# Access Compliance Report

### (Curb Ramps)

Intersection ID: 46490	Main Street: BERE_ISLAND_DR	Cross Street: BALLYBAY_DR	Location: SW
ADA ID: 5AB38DDE5678	Ramp Type: Perp	Initial Pass/Fail: Fail	Overall Compliance: No
Severity Score: 8.75			
Codes/Mitigation Info/Possible Solution		Field Measurements/Component Compliance

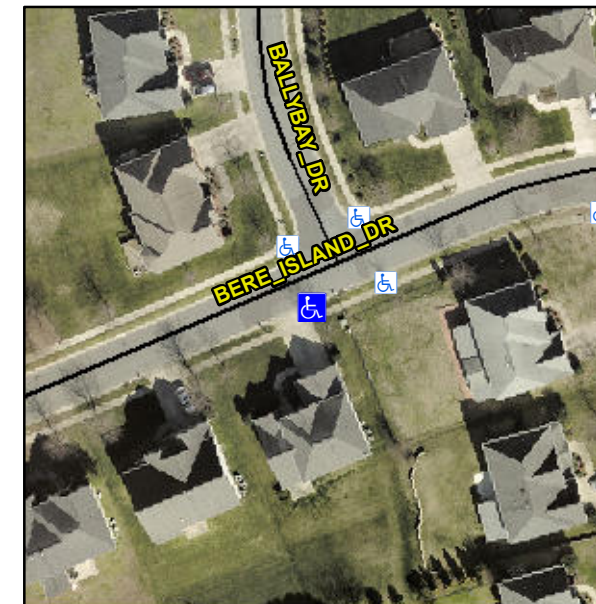
**Not Found, R304.5.1**

Compliance	Description	Data	Compliance	Description	Data
N/A	Ramp Length (in)	50.0	Yes	Ramp Slope (%)	6.1
No	Ramp Width (in)	47.0	Yes	Ramp XSlope (%)	1.5
N/A	Flare Type LT	N/A	N/A	Flare Type RT	N/A
N/A	Flare Slope LT (%)	N/A	N/A	Flare Slope RT (%)	N/A
N/A	Flare Traversable LT?	N/A	N/A	Flare Traversable RT?	N/A
N/A	Landing Length (in)	N/A	N/A	DWS Provided?	N/A
N/A	Landing Width (in)	N/A	N/A	DWS Contrast?	N/A
N/A	Landing Slope (%)	N/A	N/A	DWS Length (in)	N/A
N/A	Landing X Slope (%)	N/A	N/A	DWS Full Width?	N/A
N/A	Landing Curb? (Y/N)	N/A	N/A	DWS Offset (in)	N/A
N/A	Shared Landing?	N/A			
N/A	Gutter Ponding?	N/A	N/A	Gutter Slope (%)	N/A
N/A	Gutter Lip Ht (in)	N/A	N/A	Gutter X Slope (%)	N/A
N/A	Painted X Walk1?	No	N/A	Painted X Walk2?	N/A
	X Walk 1 Direction	To NW		X Walk 2 Direction	N/A
N/A	X Walk 1 Width (in)	N/A	N/A	X Walk 2 Width (in)	N/A
	X Walk 1 Slope (%)	1.4		X Walk 2 Slope (%)	N/A
	X Walk 1 X Slope (%)	1.0		X Walk 2 X Slope (%)	N/A

**Remove & Replace Entire Ramp.**
